Ms. Tricia L. DeBleeckere  
Minnesota Public Utilities Commission  
121 7<sup>th</sup> Place East STE 350, St. Paul, MN 55101

RE: Big Blue Site Permit Major Deviations – Noise Model Discrepancy

September 20, 2017

This is the map they submitted on October 12, 2011. The red circles are turbine bases of the G97 which supposedly the noise model concluded only 55 db.

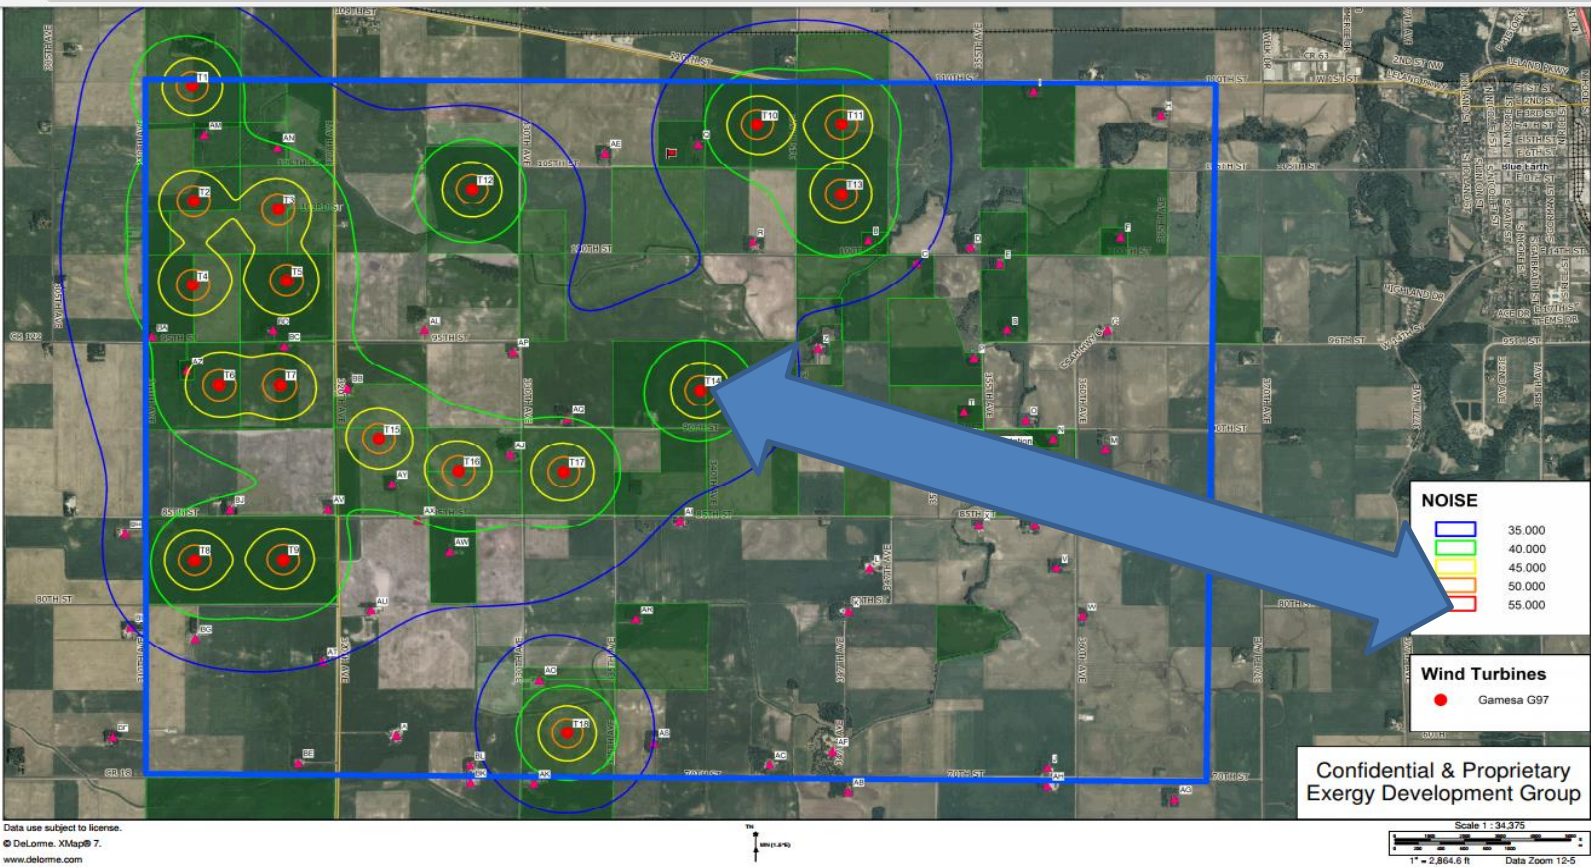
In my opinion, just because they submitted a wind turbine noise analysis cute map, doesn’t mean they actually did any of the work. How could they come to the conclusion of the turbines complying with the MPCA sound requirements when they already had micro-sighted the turbine locations?

Another key element on their cute pretty map shows a red circle at each turbine base, which they say their model study produced db level of 55, however their own study showed at the base of each turbine was 75 to 85 db. I believe they took the data from the study model of the Repower MM92 and created a map for the Commission to satisfy their compliance, hoping they would never get caught.

This is a screenshot of the actual noise study results of the Repower MM92. Appendix24 Docket # 201012-57189-07. The turbine sites are different.

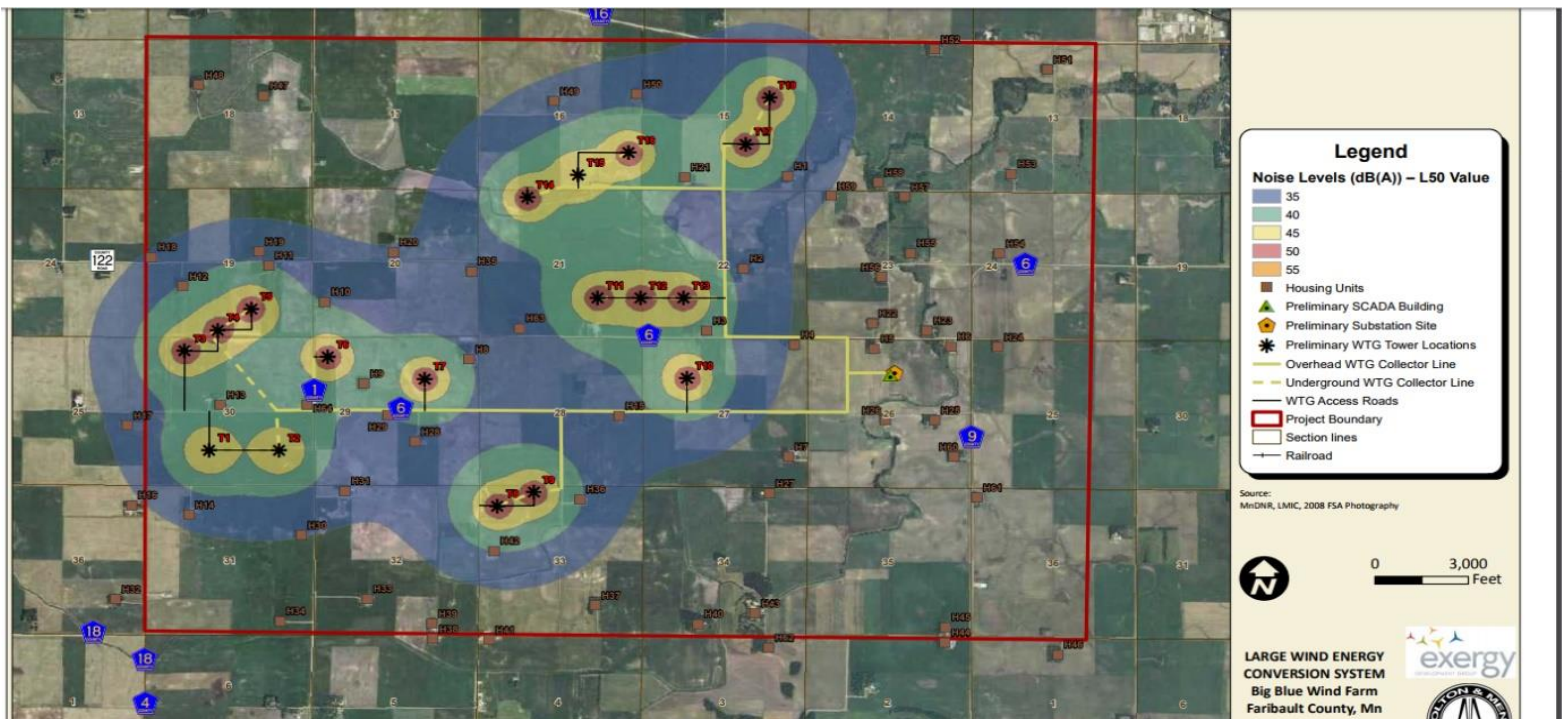
They actually did do the noise analysis modeling for the MM92, which is supported by the many pages of raw data and statistical results. But then I believe they conveniently used those study results to micro-site the G97’s when they finally decided to build the G97’s. How can that be allowed? The Repower MM92 and the G97 are extremely different turbines. They have different blade configurations and different noise outputs. And the MM92 is much quieter from the factory supplied noise parameters. It appears to me the orange, yellow, green and blue circles were hand drawn to copy the actual noise results from the noise study of the MM92.

*This is the noise meter they used*

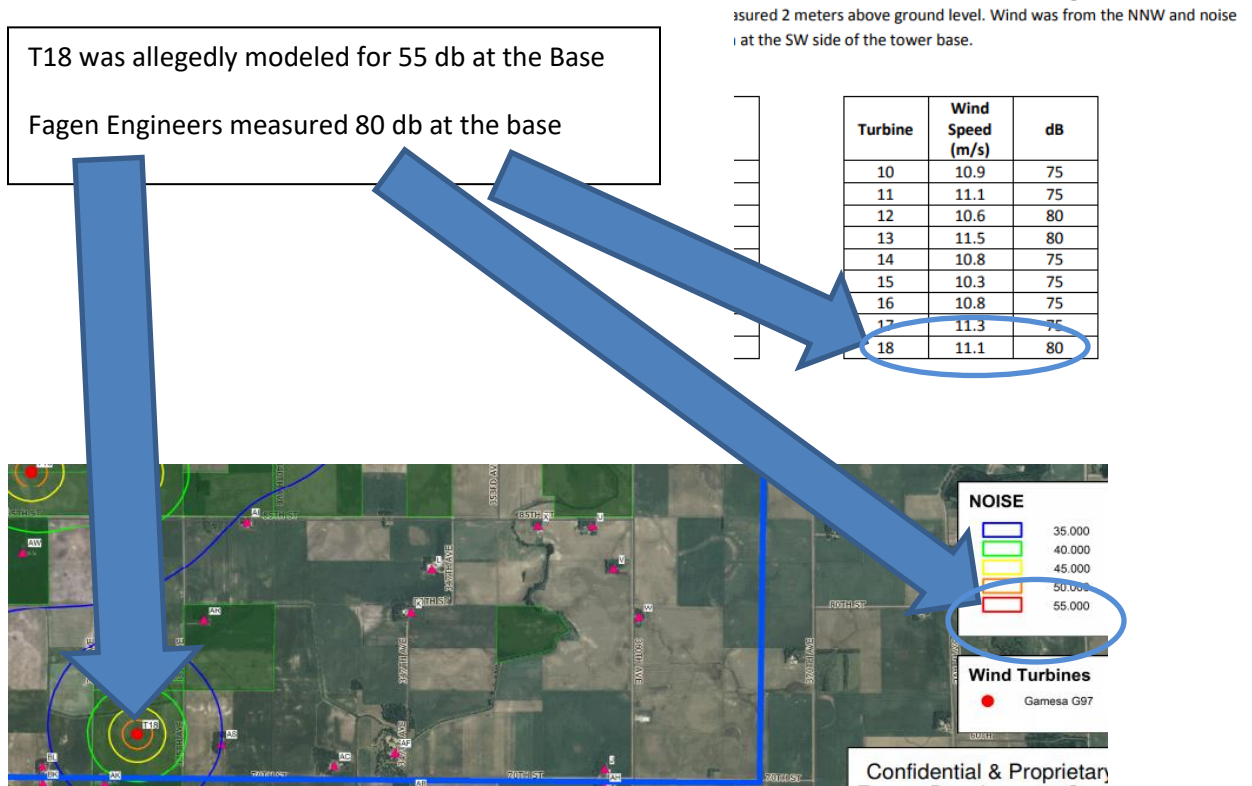
This document says they analyzed the noise at the bases of each turbine using a meter that anyone can get on Amazon for \$279 bucks, and their Android App. Was the Extech 407736 Dual Range Type 2 Sound Lever Meter calibrated to log the sound level on the 'A' scale as well as the sound pressure levels in the octave bands from 31.5 Hz to 8,000 Hz? Is this lackluster, thoughtless, and meaningless noise study acceptable to the Commission?
